**ENGINE—3.0L 2V (VULCAN) REVISED OIL PAN
GASKET REPLACEMENT PROCEDURE—NEW
SERVICE KIT—SERVICE TIP**

**Article No.
03-5-3**

Article **01-12-4** is being republished in its entirety to update the Service Parts involved.

Figure 1 - Article 03-5-3

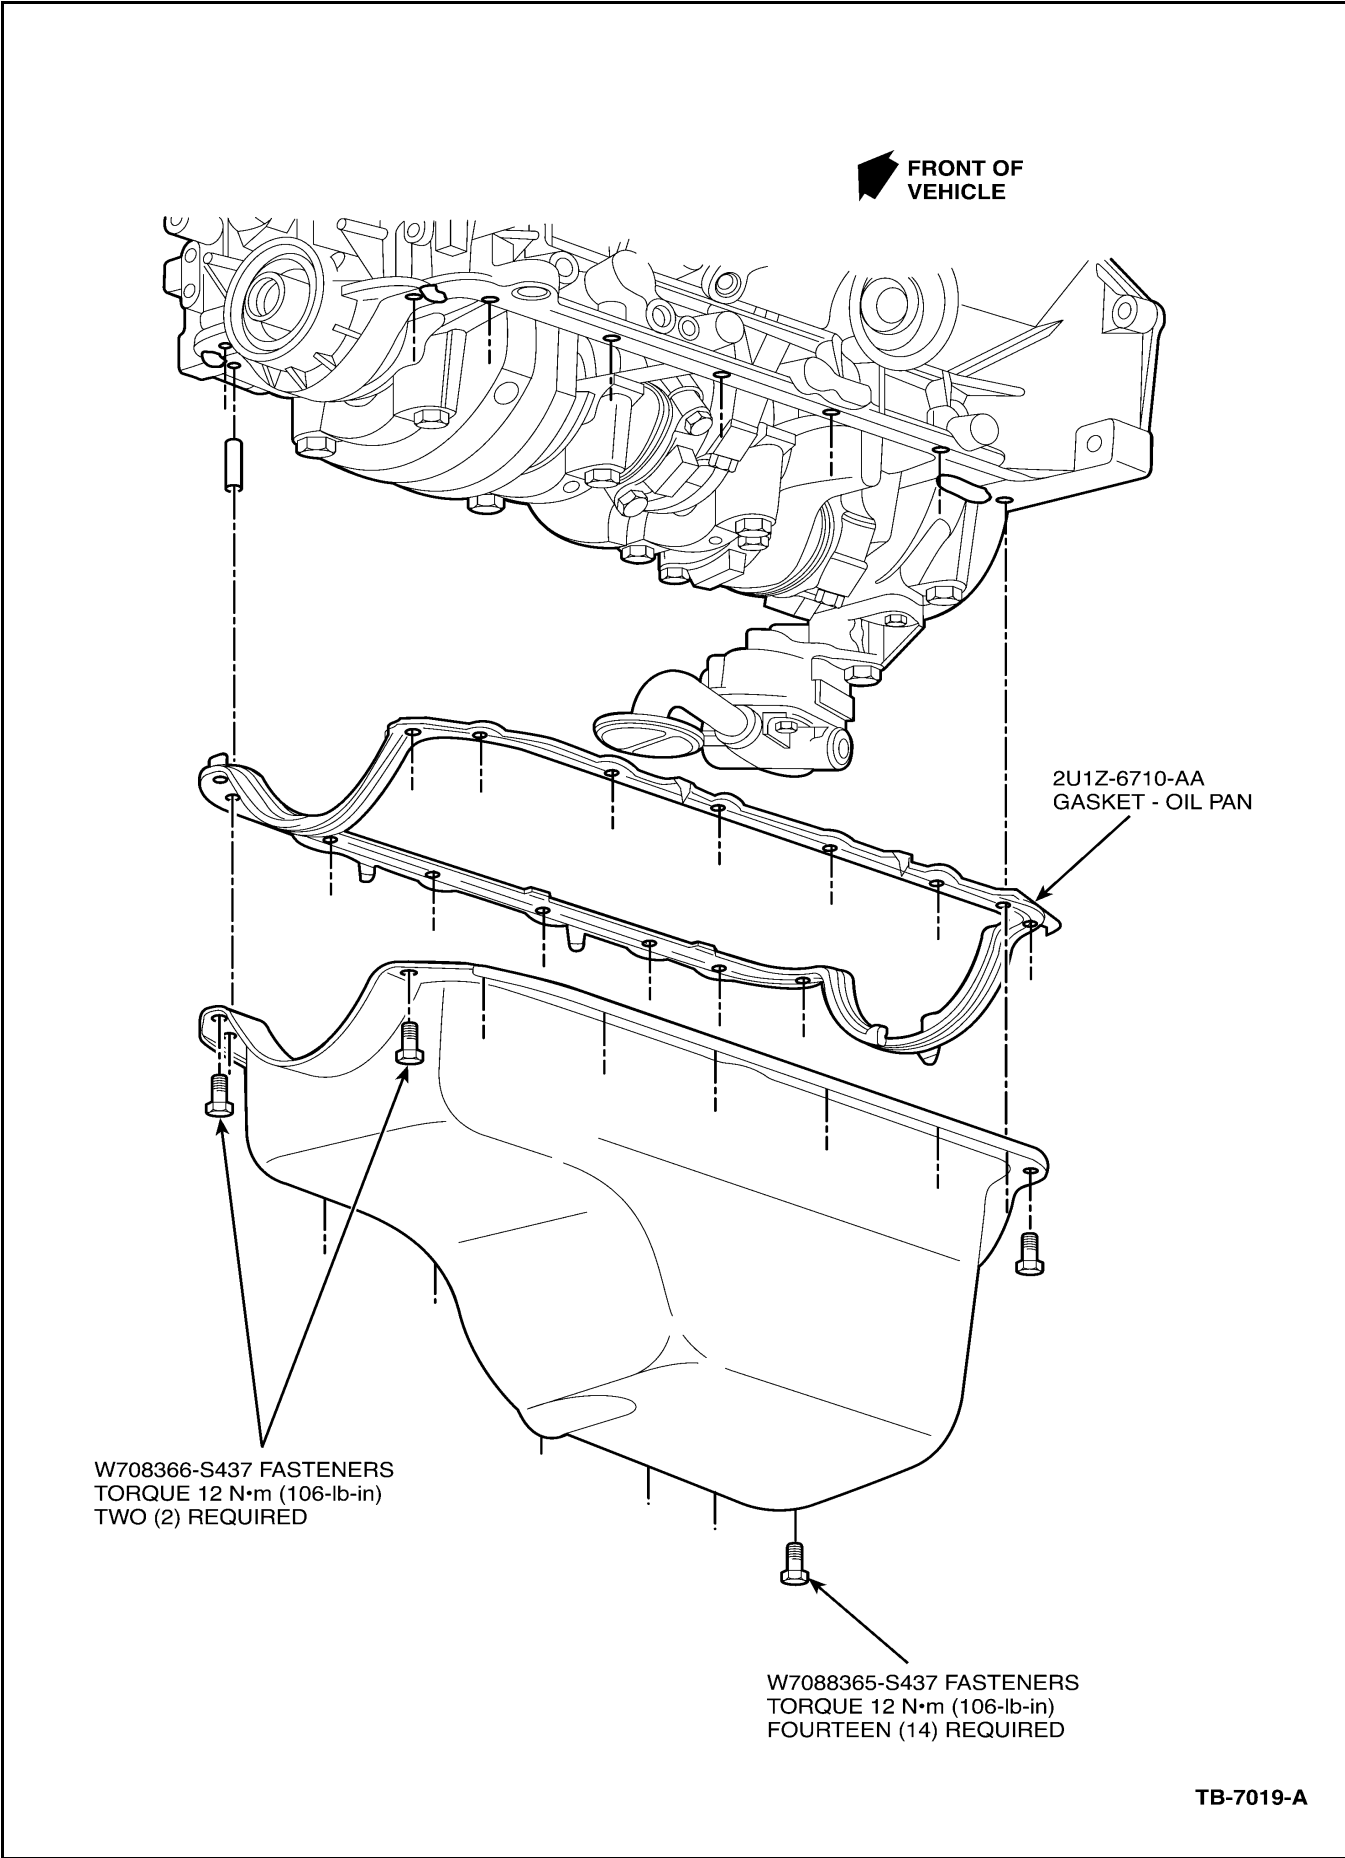
4. Install the gasket on the oil pan, being careful not to damage the plastic tabs.
5. Install the oil pan to the engine block with the new fastener (bolts) packaged in the service kit, run down all the bolts by hand (Figure 1).

6. Tighten the four (4) corner bolts first to 106 Lb-in (12 N•m).
7. Tighten the remaining fourteen (14) bolts from back to front (alternating from side to side) to 106 Lb-in (12 N•m). Figure 1.

THE TWO CORNER BOLTS NEAR THE FRONT OF THE ENGINE ARE A DIFFERENT LENGTH.

Figure 2 - Article 03-5-3

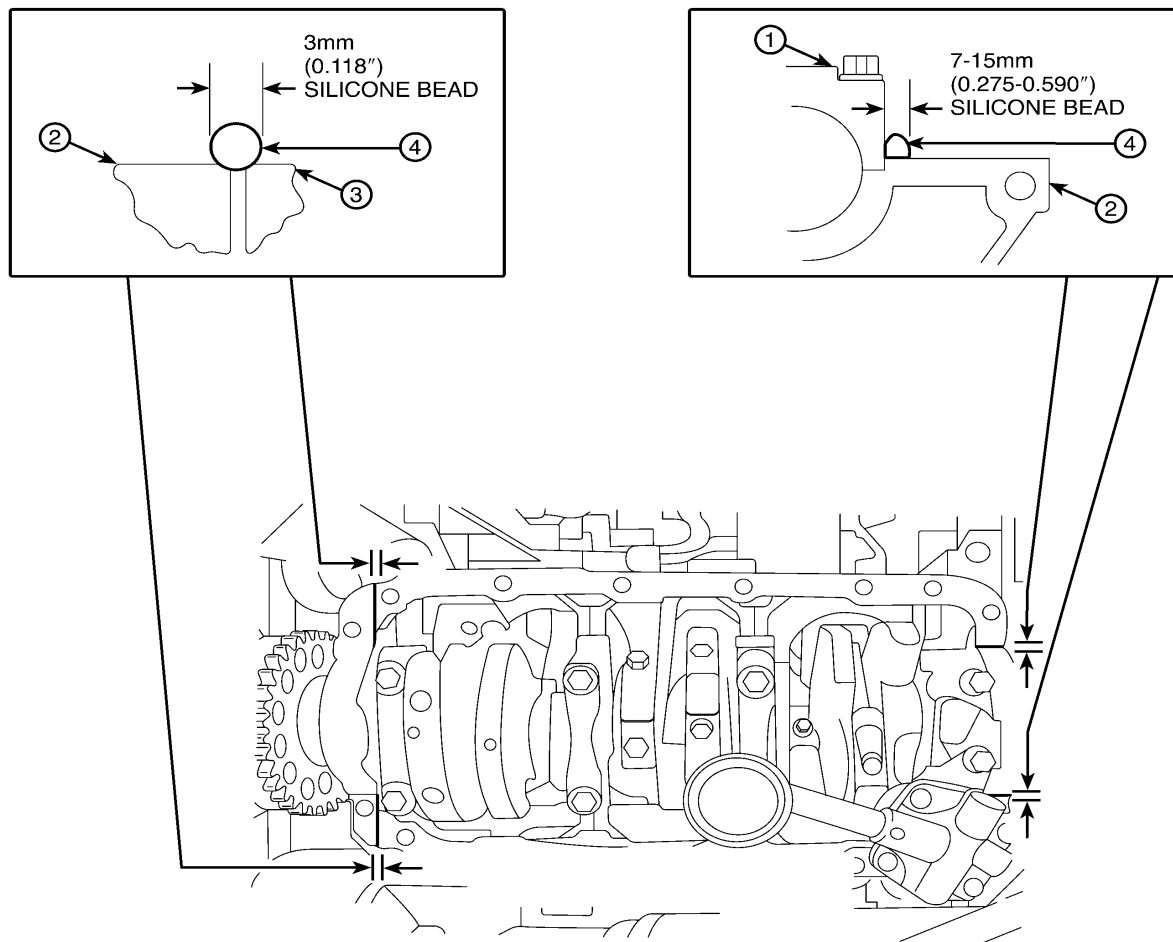
3. Apply beads of Silicone Gasket and Sealant (F7AZ-19554-EA), or equivalent meeting Ford specification (WSE-M4G323-A4) to the front cover and rear bearing cap-to-block parting lines (Figure 2).
